REQUEST FOR PROPOSALS
PARK STORE

CARNEIGIE STATE VEHICULAR RECREATION AREA

Addendum #1

ERRATA #1
April 24, 2009

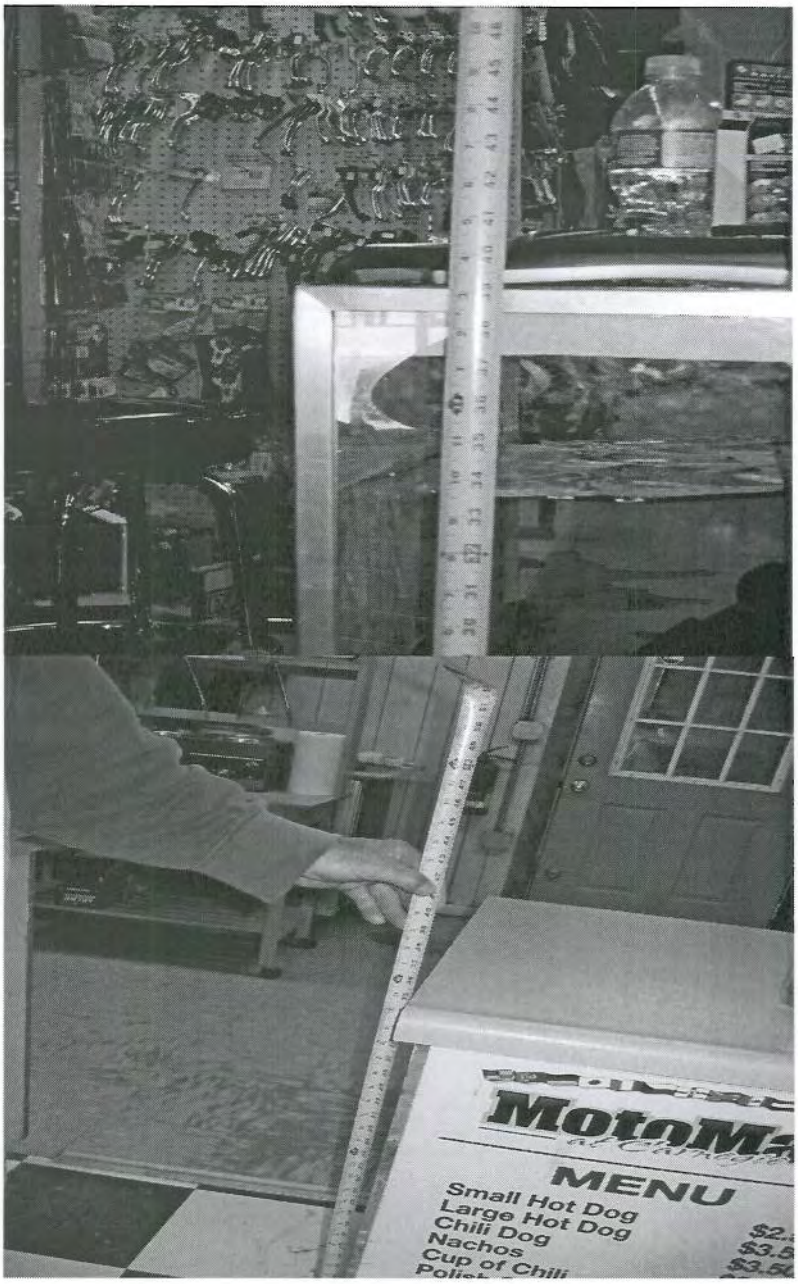
These photos show the height of the two sales counters. Both counters need to be an accessible height. The requirement is 36" of accessible counter length for every 12' feet of counter. Maximum counter height is 34" from finished floor.

There needs to be a minimum of 6' of lowered counter for the sales area and an additional 3' of lowered counter for the food area.
